<u>∕R1∖ REVISION 1</u>

PEGUIS PAVILION UPGRADES AND ENTRY ADDITION BIDDING #913-2011

TYPICAL CONCRETE REPAIR DETAILS

<u>PHOTO #1:</u> EXTERIOR BALCONY SHOWING AREAS OF PITTING AND SCALING.

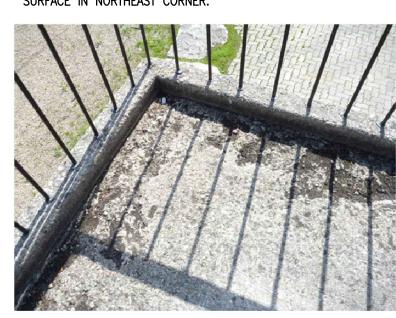
SUMMER 2011. • THE SURFACE OF THE EXTERIOR BALCONY AREA EXHIBITS PITTING AND MODERATE TO SEVERE SCALING OF THE SURFACE CONSISTENT WITH FREEZE-THAW DETERIORATION. REPAIRS ARE REQUIRED TO ADDRESS THE LOSS IN SECTION, PROTECT THE TOP REINFORCING STEEL, AND PROVIDE A SMOOTH SOUND SURFACE FOR THE WATERPROOFING MEMBRANE. CHAIN DRAG SOUNDINGS HAVE IDENTIFIED APPROXIMATELY 100 SQ.FT. OF TOP SURFACE SCALING AND APPROXIMATELY 15 SQ.FT. OF TOP SURFACE DELAMINATION. REFER TO PHOTOGRAPHS #1, #2, AND #5 INCLUDED WITH THIS ADDENDUM.

PHOTO #3: CRACKING AND DELAMINATION OF STAIR

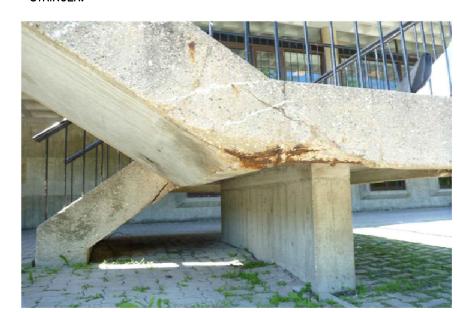
• EXTENSIVE DELAMINATION AND SPALLING OF THE CONCRETE STAIR STRINGERS WAS OBSERVED AT THE NORTH EXTERIOR STAIR. REPAIR OF THE STAIR STRINGERS IS REQUIRED. REFER TO PHOTOGRAPHS #3 AND #4 INCLUDED WITH THIS ADDENDUM.
